# Access Compliance Report

## Public Rights-of-Way

### (Curb Ramps)

Intersection ID: 10031996	Main Street: MONROE_RD	Cross Street: N/A	Location: NE
ADA ID: 498BB97C1CD5	Ramp Type: PerpDiag	Initial Pass/Fail: Fail	Overall Compliance: No
		Severity Score: 25

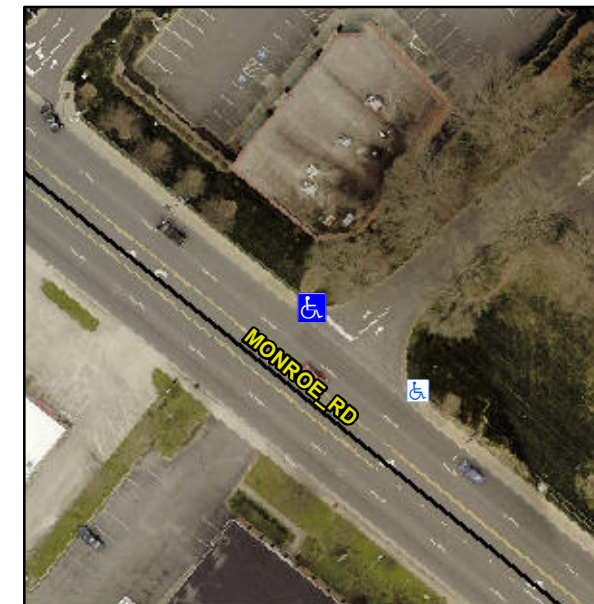
Compliance	Description	Data	Compliance	Description	Data
N/A	Ramp Length (in)	31.0	No	Ramp Slope (%)	12.1
Yes	Ramp Width (in)	48.0	Yes	Ramp XSlope (%)	0.2
N/A	Flare Type LT	N/A	N/A	Flare Type RT	N/A
N/A	Flare Slope LT (%)	N/A	N/A	Flare Slope RT (%)	N/A
N/A	Flare Traversable LT?	N/A	N/A	Flare Traversable RT?	N/A
N/A	Landing Length (in)	N/A	N/A	DWS Provided?	N/A
N/A	Landing Width (in)	N/A	N/A	DWS Contrast?	N/A
N/A	Landing Slope (%)	N/A	N/A	DWS Length (in)	N/A
N/A	Landing X Slope (%)	N/A	N/A	DWS Full Width?	N/A
N/A	Landing Curb? (Y/N)	N/A	N/A	DWS Offset (in)	N/A
N/A	Shared Landing?	N/A			
N/A	Gutter Ponding?	N/A	N/A	Gutter Slope (%)	N/A
N/A	Gutter Lip Ht (in)	N/A	N/A	Gutter X Slope (%)	N/A
N/A	Painted X Walk1?	No	N/A	Painted X Walk2?	No
	X Walk 1 Direction	To SW		X Walk 2 Direction	To SE
N/A	X Walk 1 Width (in)	N/A	N/A	X Walk 2 Width (in)	N/A
	X Walk 1 Slope (%)	1.3		X Walk 2 Slope (%)	4.5
	X Walk 1 X Slope (%)	3.1		X Walk 2 X Slope (%)	6.8

**Remove & Replace Curb Ramp With Two New Directional Ramps or Equivalent.**

**R304.2.2**
